TOWN OF GANDER

ADDENDUM NO. 2

RFQ24-11 Request for Quote -Roof Replacement at Pump House, Gander Lake

GANDER LAKE PUMP HOUSE
ROOF REPLACEMENT

Drawing Number: 24-501

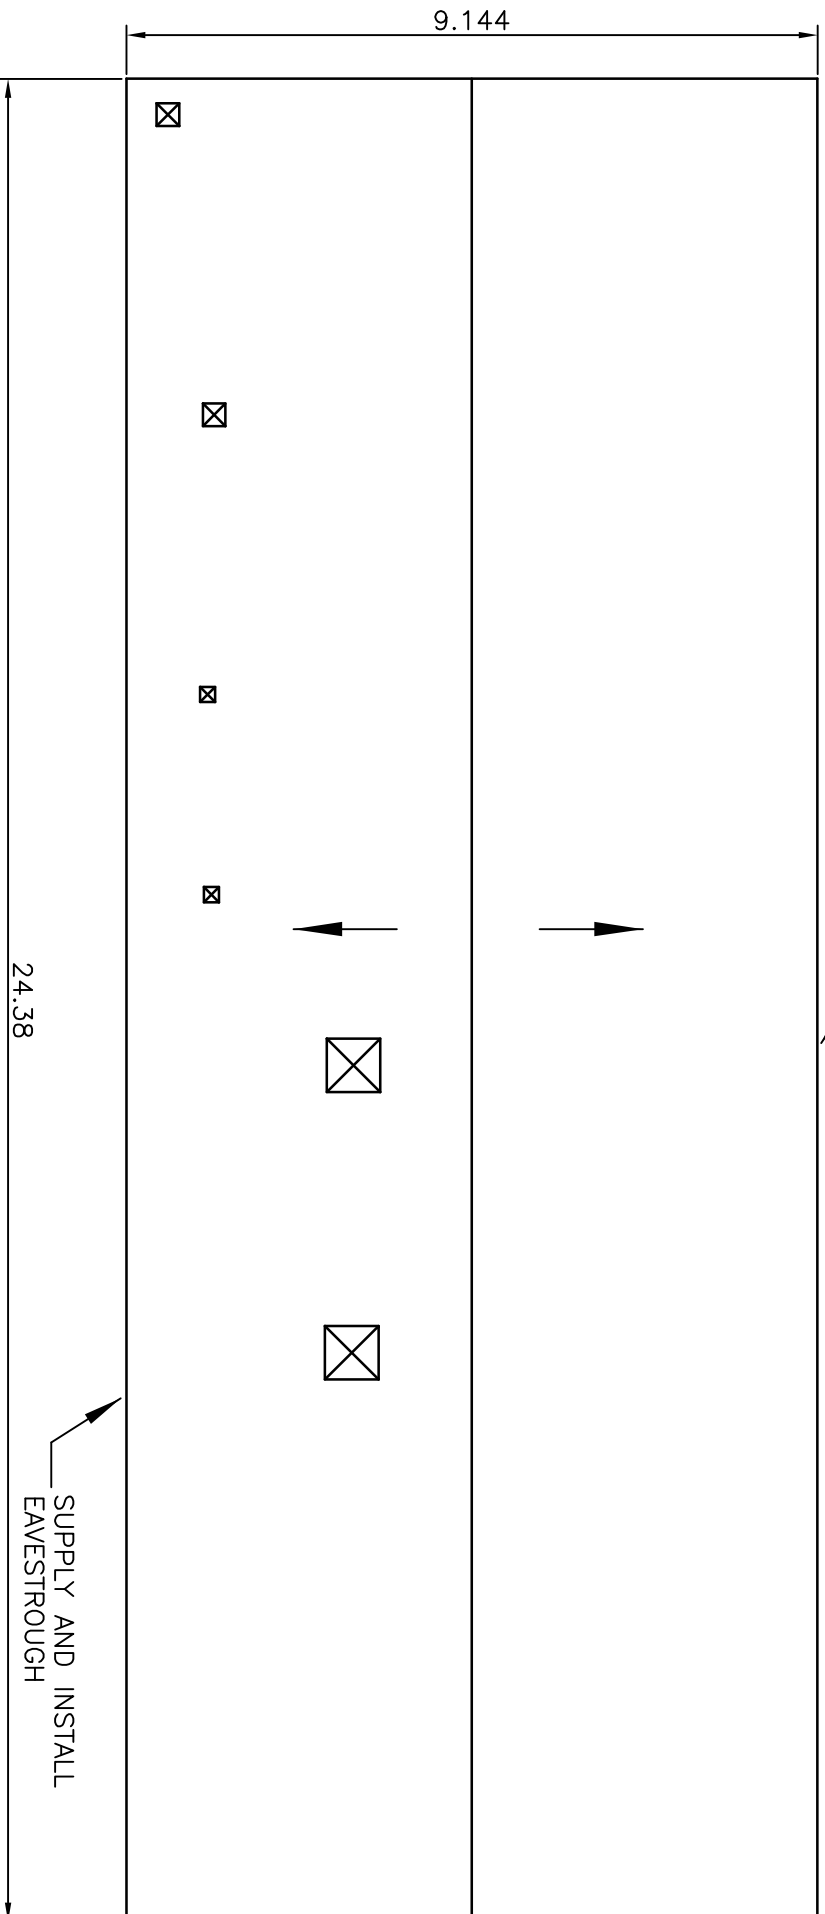
Remove the following.

See attached Sketch #24-501 and specifications.

Replace With the following.

See attached Sketch #24-501 REVISED and specifications.
